## **FAQs from 2017-08-30**

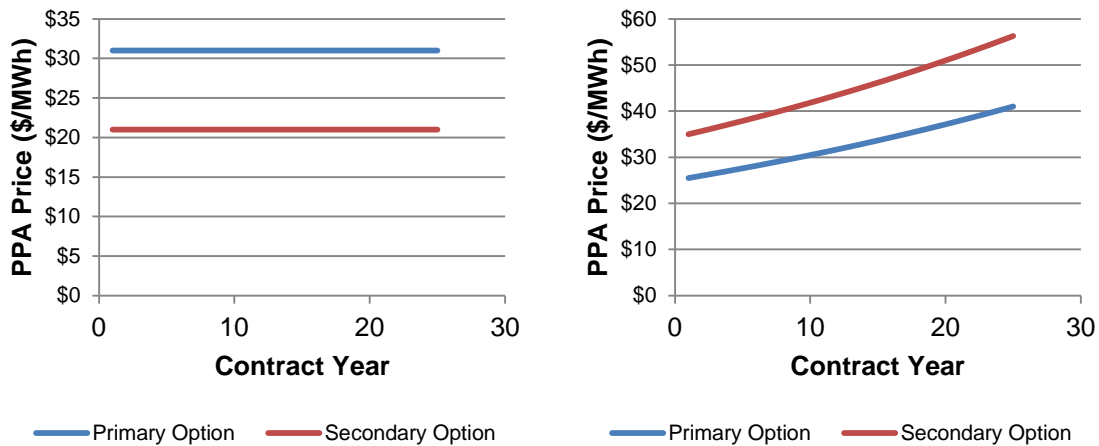
**Q: What situations could proposals be considered a single bid and what would they be considered to be multiple bids? (Updated & Expanded from 2017-10-05)**

The Company would accept multiple options for price under a single bid fee, provided the intention is to reshape the revenue stream, for example by offering flat and escalating price options, and provided that the Present Value of these pricing options is approximately equal. The below graphics contain examples.

The Company would consider the options on this project to count under a single bid fee, since its options yield very similar Present Values,
